BCI Joist Top Flange Repair Detail

Project Number: 18-191
Builder: Saint Aubyn Homes
Plan: 1932.1
Address: 9754 Rubicon
City, St: Colorado Springs, CO
Supplier: BMC
Distributor: Boise BBMD - Denver
Date: June 22, 2018

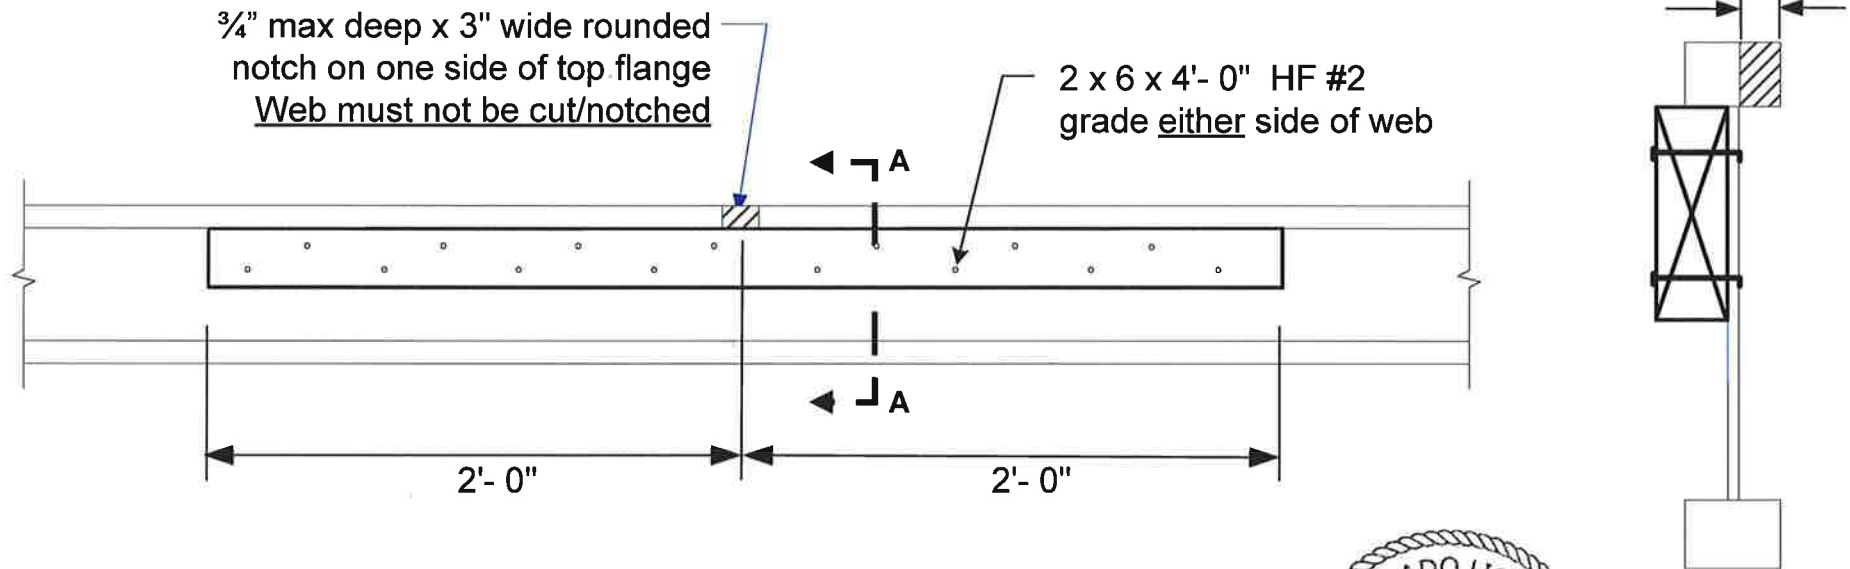
Joist: 9-1/2" BCI 5000 1.7
Loading: 40/15 psf
Spacing: 19.2" on-center
Span Length: 14'- 0", 3'- 0" (multi-span)
Notch/Hole Location: 2'- 10" from end bearing
on 14'- 0" span

- Notes:
- 1) Install 2 x 6 tight to underside of top flange
 - 2) Glue 2 x 6 to web with floor panel adhesive
 - 3) Nail 2 x 6 with 2 rows 10d nails @ 6" on-center, staggered. Clinch all nails on web.
